L-2011-155 10 CFR 52.3

Re: Florida Power & Light Company Proposed Turkey Point Units 6 and 7 Docket Nos. 52-040 and 52-041
 Response to NRC Environmental Request for Additional Information Letter 1103071 (RAI 5498) Environmental Standard Review Plan Section 5.7 – Meteorology and Air Quality Impacts

NRC RAI Number: EIS 05.07-2 (RAI 5498)

Figure 5.3-1 Predicted Monthly Salt Deposition

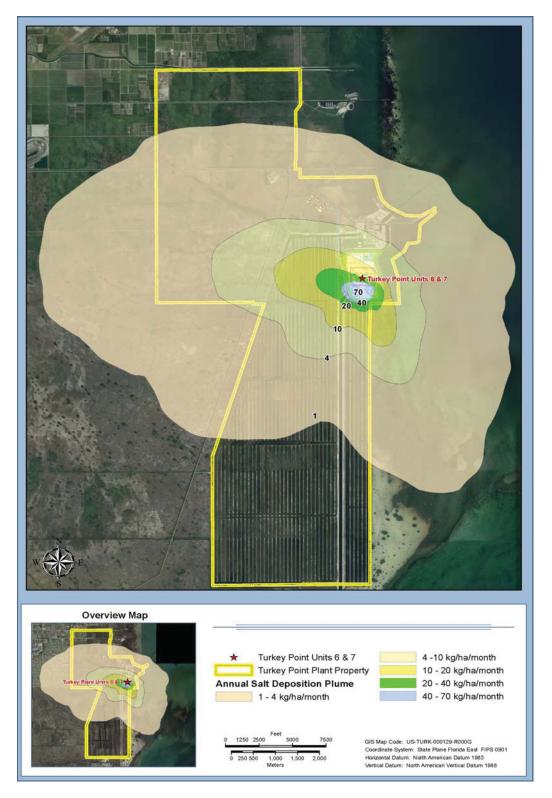
Provide an explanation as to why one cooling tower particle size distribution is different from that of the other five towers. Also provide information that documents and supports the particle size distribution used in this analysis using the TDS of 50,000 ppm.

Provide an explanation as to why this one cooling tower is different from the other five towers. Also provide information that documents and supports the particle size distribution used in this analysis using the TDS of 50,000 ppm.

The revised modeling approach resulted in a slightly larger salt deposition plume, as depicted on Figure 5.3-1. However, the salt deposition area of greater than 10 kg/ha/mo (the level that could cause leaf damage in many species) would generally be confined to the plant property and is little changed from the original modeling approach. In addition, impacts to the crocodile areas (Figure 5.3-2) are also little changed from the original modeling approach. It is important to note that the AERMOD modeling assumed the radial collector wells are in operation full-time, resulting in a continuous TDS concentration of 50,000 ppm in the saltwater droplet emission. The radial collector wells are the back-up CWS water source that will be used intermittently when the primary source – reclaimed water – is not available. Therefore, the annual salt deposition plume, based on the assumption of continual radial collector wells operation, is likely much larger than what would be expected from reclaimed water use in the CWS.

The maximum predicted salt deposition rate to the industrial wastewater facility in the vicinity of the cooling towers ranges from 140 to 7080 kg/ha/month (annual basis; see Figure 5.3-1). This annualized salt deposition range of 140 to 7080 kg/ha/month was normalized to salinity based on the annual site rainfall (approximately 58 inches annually). The resulting salinity range was calculated to be approximately 0.00080.03 to 0.06 parts per thousand (ppt).

Revised ER Figures 5.3-1 and 5.3-2 will be included in a future COLA revision to reflect the RAI response:
